Product change notification (PCN)

Title / short description	PSR-PSXX-... / PSR-PCXX-... / PSR-MCXX-... New outer packaging
Affected article category	Functional safety
Change category	Packaging, Marking
Change number	CDN260007-00
Reason for PCN/PDN Revision

New Lasertemplate PSR-MCXX... / PSR-PCXX... (12.5 mm width)

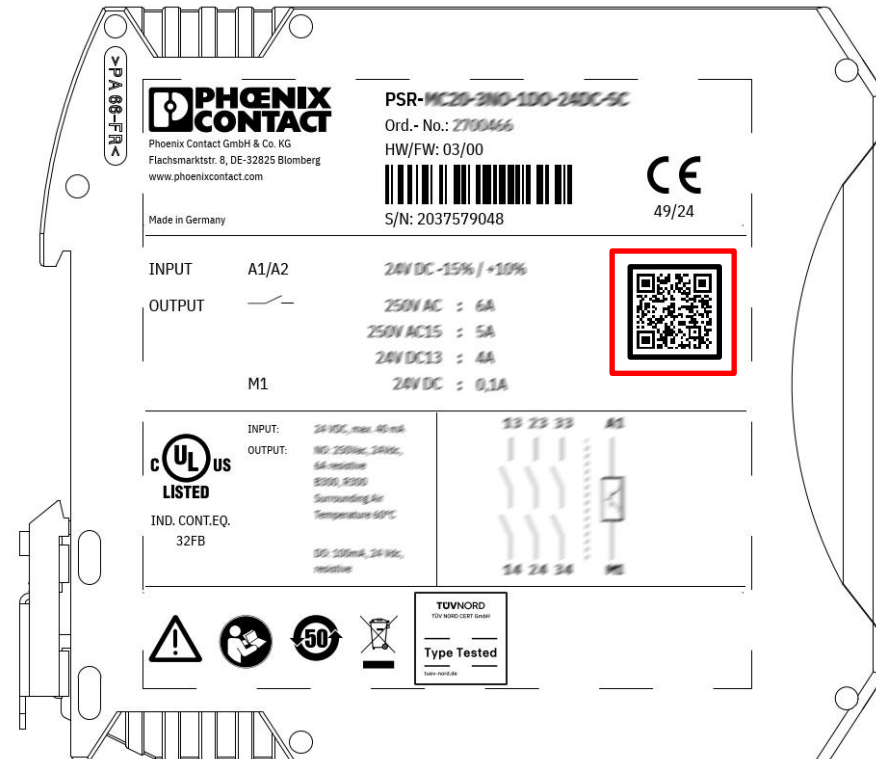
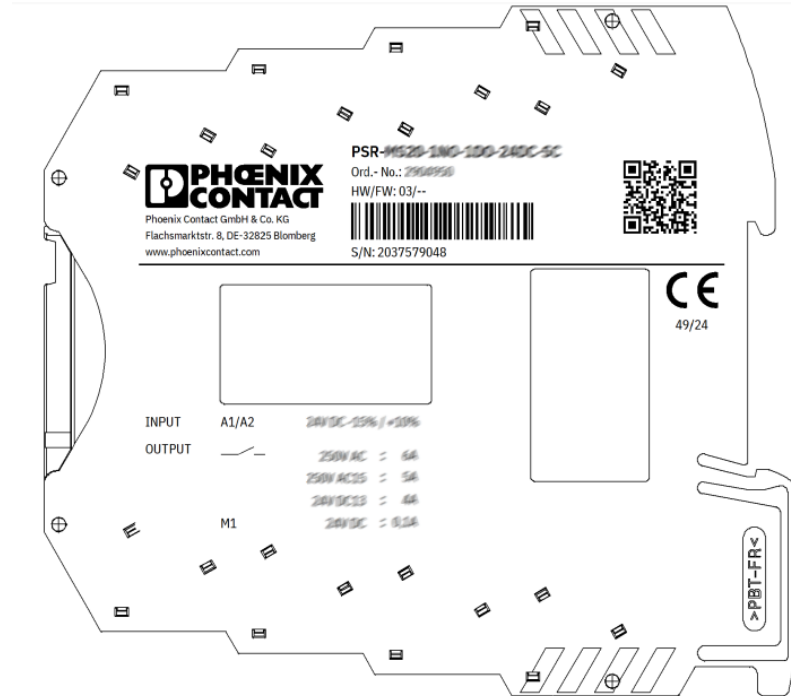
The DT4I code can be seen on the left side of the housing instead of the QR code (PSR-MCXX-... / PSR-PCXX-...) or on the right side of the housing (PSR-PSXX-...).
